## Application SCR evaluation template

Name of activity, address and NGR	<p>Evonik Goldschmidt UK Ltd (formerly Goldschmidt UK Ltd): BM4198IC</p> <p>Main Road Flimby Maryport Cumbria CA15 8RP</p> <p>National Grid Reference – NY 0163 3306</p>
Document reference of application SCR, date and version of SCRs	<p>Application Site Report, reference DEG01, July 2003 prepared by E4environmental Ltd.</p> <p>PPC Permit No. BM4198IC (decision document dated 13<sup>th</sup> January 2004 and Application Site Report Evaluation Checklist dated 14<sup>th</sup> January 2004)</p> <p>Design Site Protection and Monitoring Programme, dated 27<sup>th</sup> March 2004 prepared by Goldschmidt.</p> <p>Updated Design Site Protection and Monitoring Programme, dated 4<sup>th</sup> April 2006 prepared by Goldschmidt.</p>
Document references relevant to SCRs	<p>The following documents were submitted on 29<sup>th</sup> September 2015 in support of the application to surrender the permit:</p> <ul style="list-style-type: none"> <li>• Site Condition Report Template: not dated;</li> <li>• Operational Description Report, prepared by Brian McAvoy, not dated;</li> <li>• Site Closure Plan, reference EV SCP 2015, dated 2

Drainage plan:

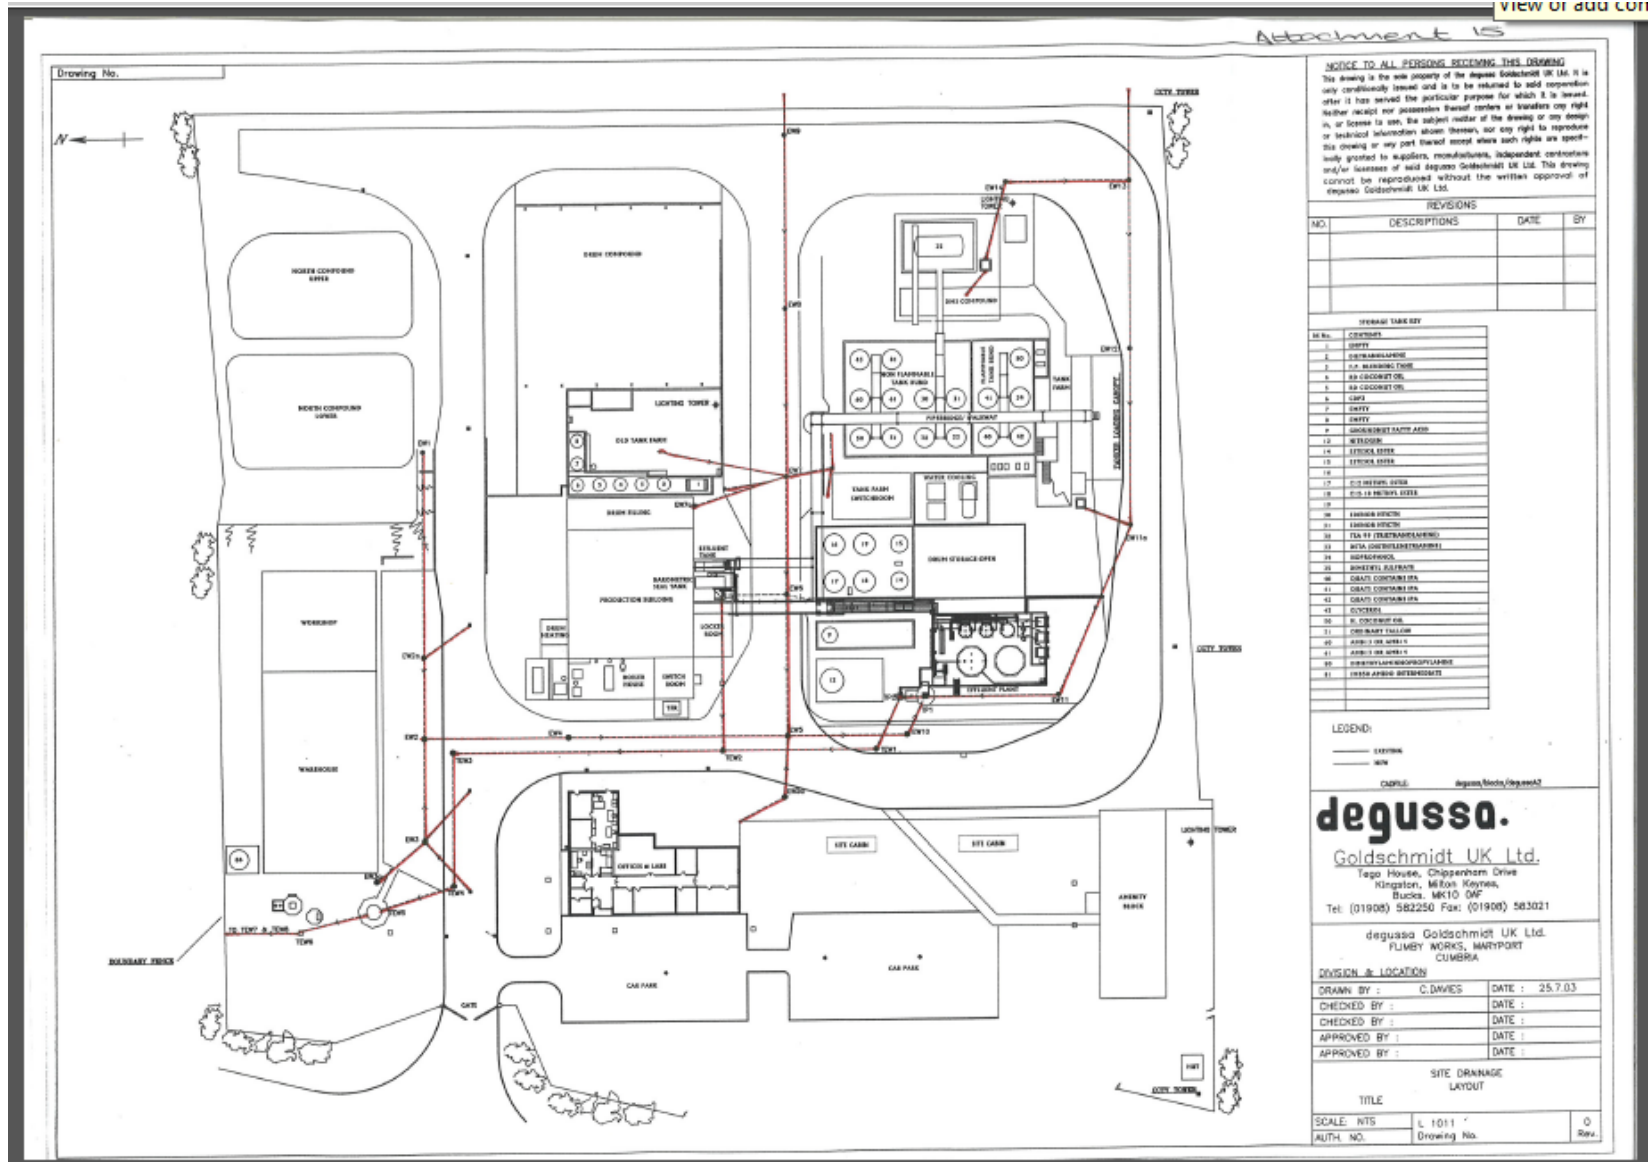
- Holes/broken pipe and a displaced joint between manholes EW1 and EW2a: this line drains a roadway at the site, the north compound and the area outside the workshop;
- Infiltration gushing in between manholes EW5 and EW6: this line is down gradient of manholes EW1 and EW2a and also carries effluent collected from the warehouse area, offices

- Displaced joints between manholes EW5 and EW9: this line collects effluent collected from the road way and the two tank farm areas;
- Cracks between manholes EW7 and EW8: this section of the line collects effluent from the road way;
- Infiltration seeping in between manholes EW11a and EW12, displaced joints between manholes EW11a and EW13 and cracks between manholes EW13 and EW14: this line is located in the tanker off loading area; and
- Cracks between manholes TEW2 and TEW3, infiltration seeping in between manholes TEW5a and TEW7 and cracks between manholes TEW8 and TEW9: this line carries treated effluent off site to connect in to the main sewer.

# Location of sampling points

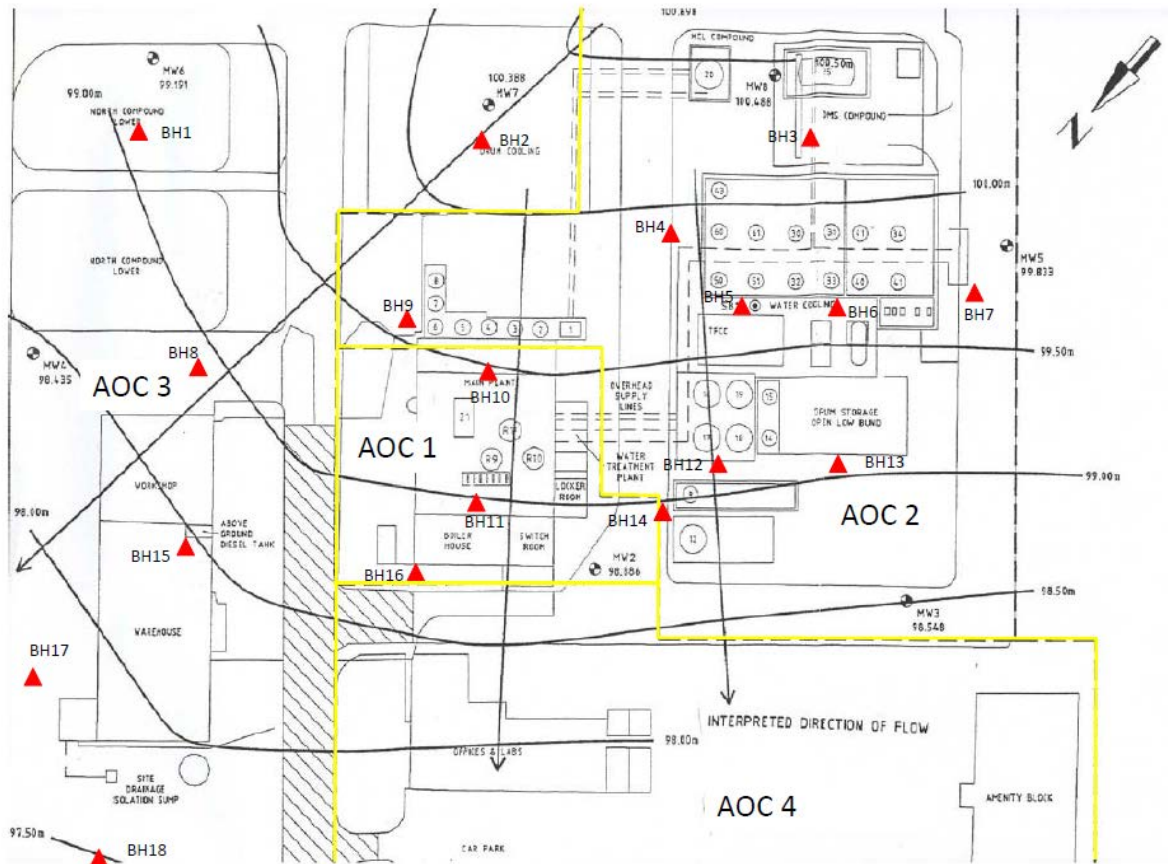
Taking this into account it is unlikely that drainage defects in the following areas could have caused contamination of the ground: between manholes EW1 to EW2a, EW5 to EW6, EW5 to EW9, EW7 to EW8 and EW11a to EW14.

Consequently, the only area of concern with regards the drainage is along the TEW line between manholes TEW2 to TEW3, TEW5a to TEW7 and TEW8 to TEW9.
